# **TORONTO** STAFF REPORT

Subject: Request for Direction Report  
Official Plan and Rezoning Application 06 104568 NNY 25 OZ  
Site Plan Application 06 112849 NNY 25 SA  
Applicant: Mccarthy Tetrault LLP  
Architect: J.F. Brennan  
2130 Bayview Ave  
Ward 25 - Don Valley West

**2130 Bayview Avenue**

**Attachment 2: Elevation 1**

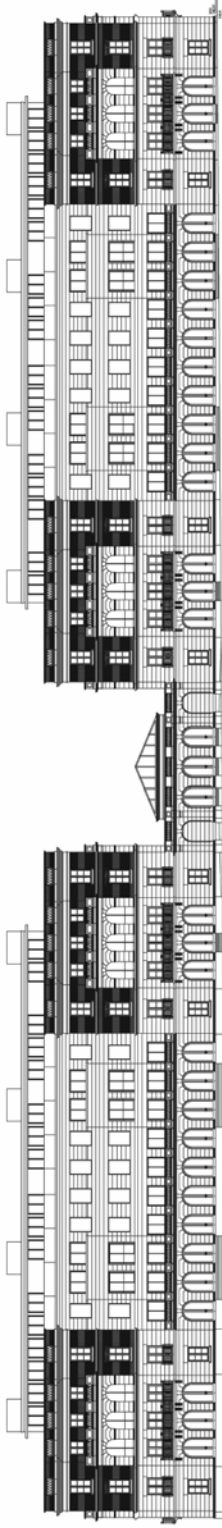
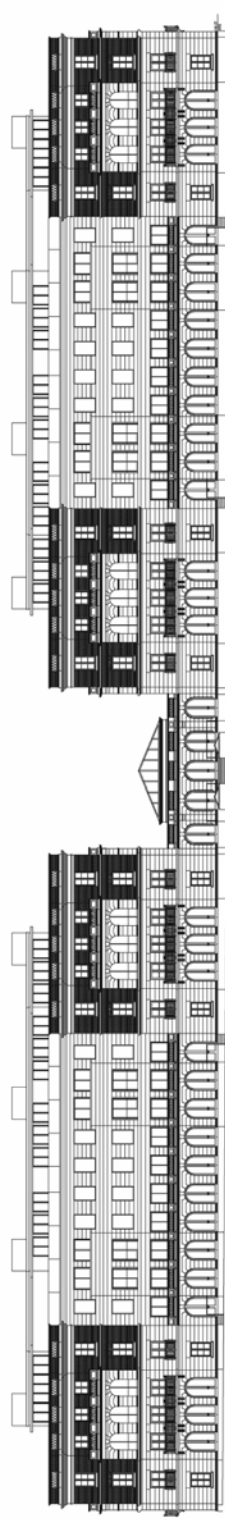
The current proposal has reduced front yard setbacks with the edge of the development being closer to the street than most buildings along this portion of Bayview. Buildings ‘1’ and ‘2’ read as long, unbroken buildings, which are not compatible with the existing character of the area. In order to preserve this campus like character along this portion of Bayview Avenue, the applicant should increase the depth of the forecourt for Building ‘2’ by providing a minimum setback of 14 meters from the property line. In addition, all of the balconies in this area should be removed to respect the open space character of Bayview Avenue. The applicant is also

encouraged to remove the balconies and increase the depth of the forecourt for Building '1' to a minimum setback of 14 metres.

1. To reinforce the existing physical character along this portion of Bayview Avenue, the depth of the forecourt of Building '2' along the Bayview frontage applicant should be increased by providing a minimum setback of 14 meters from the property line. In addition, all of the balconies in this area should be removed to create more openness within this space. The applicant is also encouraged to remove the balconies and increase the depth of the forecourt for Building '1' to a minimum setback of 14 metres.

Attachment 3: Elevation 2

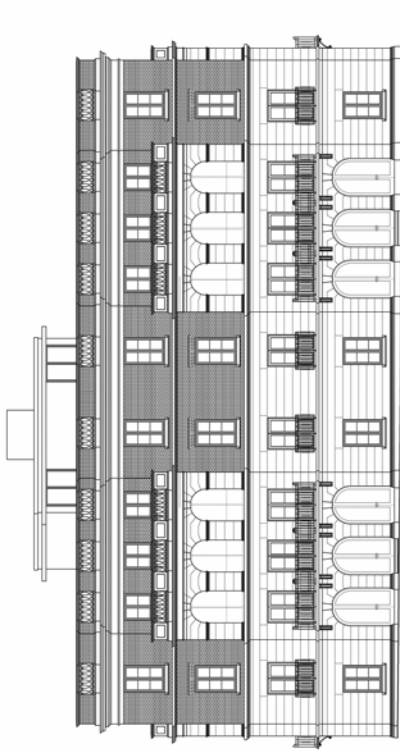
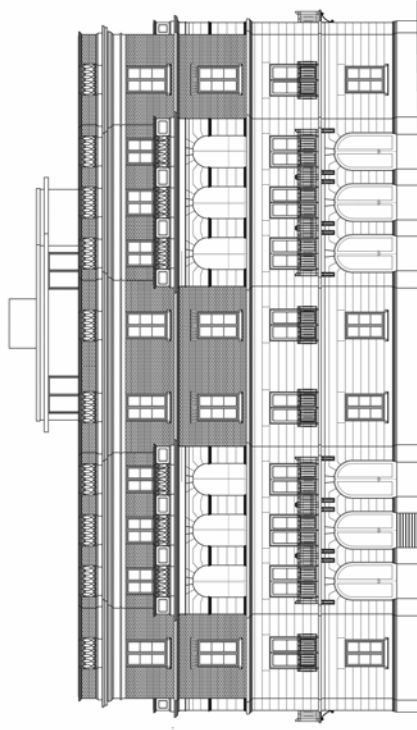
Pedestrian routes and walkways should be universally accessible through the site. The internal driveway should be moved at the south-west corner to create a minimum 1 metre setback between Building '1' and the proposed sidewalk to improve the pedestrian environment along the private driveway, and to provide privacy for the ground floor apartments.

7. To improve pedestrian amenity, the internal road should be moved at the south-west corner to create a minimum 1 metre setback between Building '1' and the sidewalk at its closest point.
8. The location of the hydro transformer and the gas regulator are currently proposed at the south end of the site. These elements need to be appropriately screened and integrated with the park edge of Stratford Park.
